PLANNING PROPOSAL TO MODIFY ZONING, HEIGHT AND FSR TO LAND AT 95-97 STANHOPE ROAD KILLARA - LOURDES RETIREMENT VILLAGE

PURPOSE OF REPORT: For Council to consider a Planning Proposal at 95-97 Stanhope Road, Killara on land currently operating as Lourdes Retirement Village.

That Council not support the request for the Planning Proposal at 95-97 Stanhope Road, Killara (Lourdes Retirement Village) and that it not be submitted for a Gateway Determination.

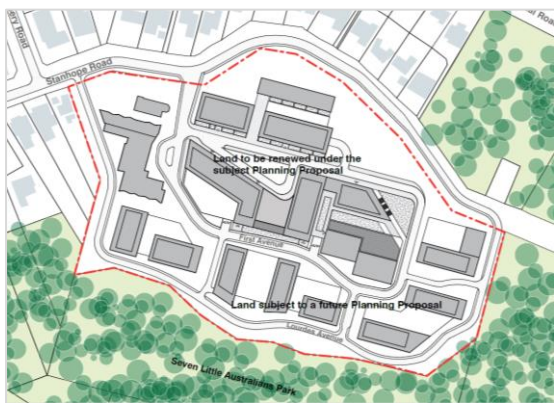
This objective, with the associated illustration of apartment block type buildings to the south of the site, is not supported and contradicts the content of the Planning Proposal which states that due to challenges around bushfire management, the southern part of the site, adjacent to the bushland, would remain as is with the existing housing.

Whilst the Planning Proposal does not seek amendment of the maximum height to this southern part of the site, it seeks to rezone the site in its entirety to R3 (Medium Density Housing), and apply the increased floor space ratio (FSR) to the whole site. This will enable the intensification of development through increased heights to the north of the site close to Stanhope Road (shaded in blue in the diagram below). The below diagram illustrates the development outcomes being sought for this site (from Urban Design Study attached to Planning Proposal).

Optus Base Station at RL 117.65 visible above tree canopy. Photo taken from Lindfield Soldiers Memorial Park and oval.
The proposal seeks an increased height to RL 127.3 making it highly visible above the canopy.

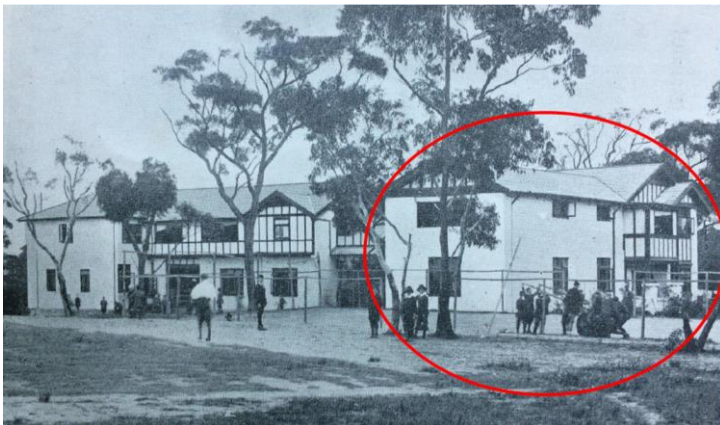
The impact on the bushwalks and their intended historical ambience as a 'bush retreat' has not been adequately addressed. A maximum building height that renders any new structure not visible above the canopy would show regard for the locally heritage listed bushland park. This would also integrate with the wider principles of the Ku-ring-gai character of buildings placed within a landscaped setting and below the tree canopy.

These are views from existing heritage conservation areas across the Seven Little Australians Park especially Crowns Block Conservation Area. At present these sites take in bush vistas but the inclusion of these buildings would result in visible built structures above the canopy. It is important that building heights on the site are below the canopy so regional vistas from conservation areas of the bush are not interrupted by new built elements; and, that the provision of deep soil areas to facilitate improved tall canopy trees be a consideration for any urban study for the site.
